Change Order

PROJECT (Name and address): Rio en Medio Meal Site Kitchen Re-model Chupadero, New Mexico 87506	CHANGE ORDER NUMBER: 003 DATE: October 7, 2011 ARCHITECT'S PROJECT NUMBER: 1031 CONTRACT DATE: 7/19/11 CONTRACT FOR: General Construction-Add remodeling of apartment into Food Storage Facility	OWNER: <input checked="" type="checkbox"/> ARCHITECT: <input checked="" type="checkbox"/> CONTRACTOR: <input checked="" type="checkbox"/> FIELD: <input type="checkbox"/> OTHER: <input type="checkbox"/>
TO CONTRACTOR (Name and address): AIC General Contractor, Inc. 2703-G Broadbent Parkway NE Albuquerque NM 87107

**Re: Rio en Medio Food Storage Facility Remodel, Chupedero, N.M.
Change Order No. 003 to the Meal site Kitchen Remodel Contract**

CHANGE ORDER REQUEST # 003

B2 FIRST FLOOR DEMOLITION PLAN
DATE: 07-11-11

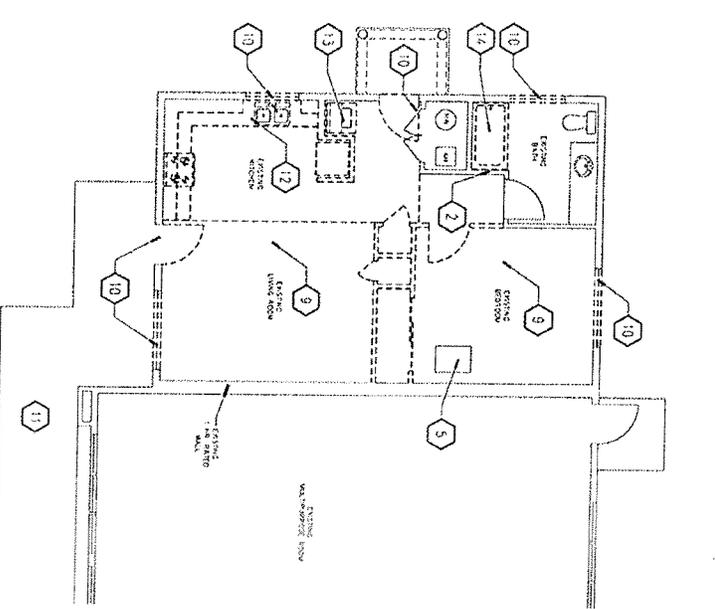
(Include, where applicable, any undisputed amount attributable to previously executed Construction Change Directives)
 Add remodeling of the existing apartment on the north side of the building for a new Food Storage Facility per request by the County of Santa Fe. This Change Order does not include NMGRS which is to be added to the Application and Certificate for Payment.

The additional work proposed in Change Order No. 003, as requested by the County of Santa Fe, includes remodeling the existing apartment on the north end of the Rio en Medio Community Center into a Food Storage Facility for the County of Santa Fe. The contractor, AIC General Contractor, is already on site for the remodel of the Meal Site Kitchen, so to proceed with the proposed Change Order No. 3 to AIC's contract will expedite the work of the Food Storage remodel in regards to pricing, mobilization, and permitting (amending the existing Building Permit) for the job.
